RE: **McDonalds – McMahon Market Place, Lot 7** **A11-D011B**
SW Corner of McMahon & Fineland NW PE Stamp: - N/A (12/2/13 plot)
Conceptual Grading & Drainage Plan - Site Plan for Building Permit

Based upon the information provided in your submittal received 12-04-2013, the above referenced **Conceptual Plan is approved for Site Development Plan for Building Permit.**

**McMAHON MARKET PLACE
 McDONALD'S RESTAURANT**
 SHELL BUILDING, ALBUQUERQUE, NM 87114

CONCEPTUAL GRADING AND DRAINAGE PLAN

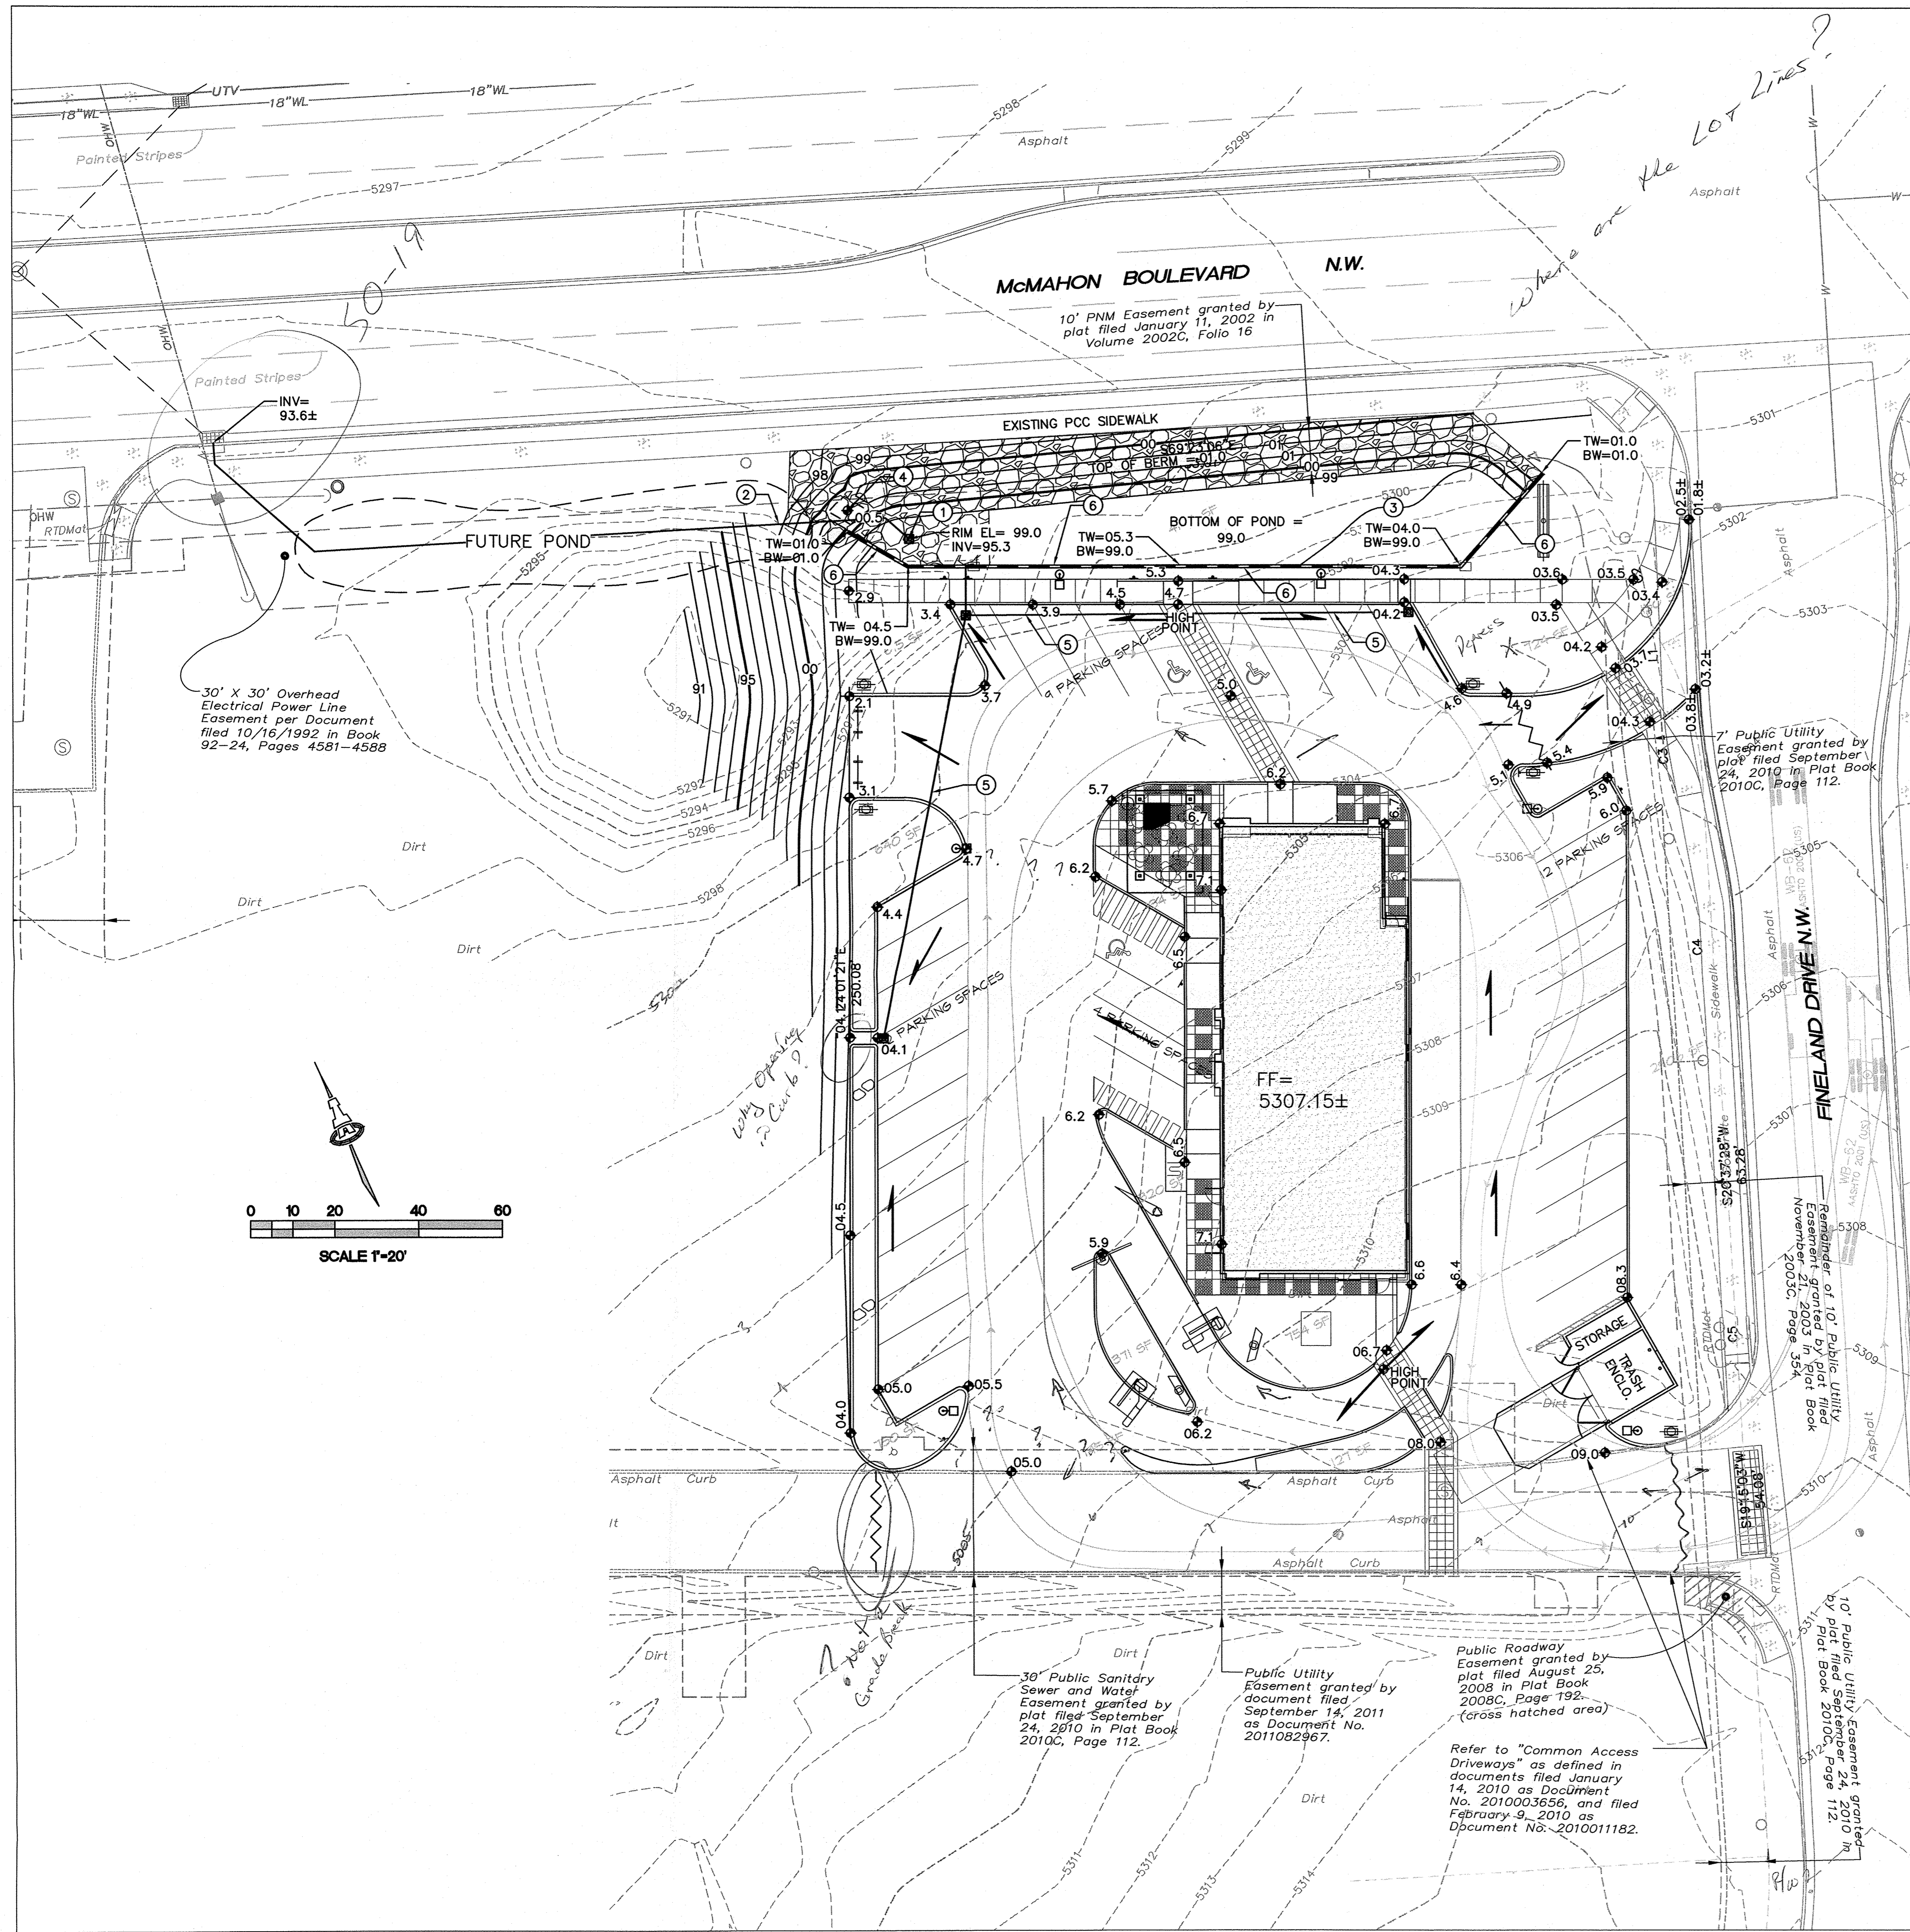
- The proposed curb opening on the east side of the parking lot may need erosion protection on the discharge.
- The Grade Break line on the SW corner of the site is not accurate.
- SO-19 notes will be required on the Private drain line connection to the City inlet.
